Our Ref: 20-1543.06

Planning Ref : AL/87/21/PL

Location : Oldlands Farm Newlands Road Bognor Regis PO22 9FJ

Proposed : Erection of a warehouse (Use Class B8) with ancillary office, associated vehicle parking, van storage, plant, ancillary structures, lighting landscaping and infrastructure works including earthworks to facilitate flood compensation area. This site may affect listed buildings, may affect the character & appearance of the Shripney Conservation Area, is a Departure from the Development Plan, affects a Right of way & is in CIL Zone SP3 (Zero Rated) as other development.

Figure 2: Illustrative Site Layout Plan

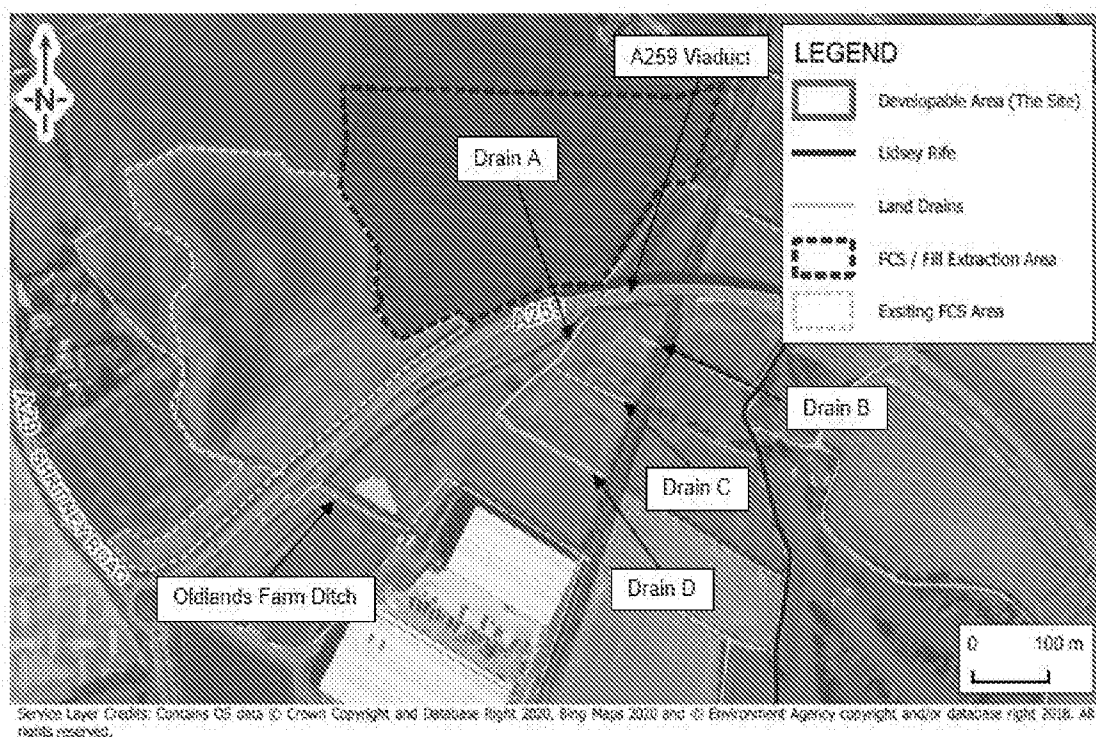
Further site investigations into the existing drainage network and the function of this system should be considered to provide more certainty that the proposals to infill and bury these ditches will not have a long-term detrimental impact. Any loss of these ditches should be compensated for, not just in terms of volume, but taking into consideration the impacts on habitat too.

There are several land drains within the Site boundary which are understood to be associated with the Sites former agricultural use. An unnamed land drain is identified to pass beneath the A259 Viaduct, this drain is shown as Drain A in the above figure. A map showing on-site and surrounding watercourses obtained from Arun District Council indicates that the Drain A flows in a north eastern direction, away from the Site (Appendix C of the FRA).

Drains B, C and D convey flows eastwards, beneath the railway lines within 450 mm diameter culverts and eventually drain into Lidsey Rife. The topographical survey (Appendix B of the FRA) shows there to be no direct connection between Drain A and Drains B, C or D.

The latest development identifies that Drain A will be maintained with sections bridged or culverted as necessary. The infilling of the upstream extents of Ditches B, C and D is not considered to have a detrimental impact given their catchment area is the Site and the Site will retain, and release water through the introduction of a drainage system constructed to modern standards.
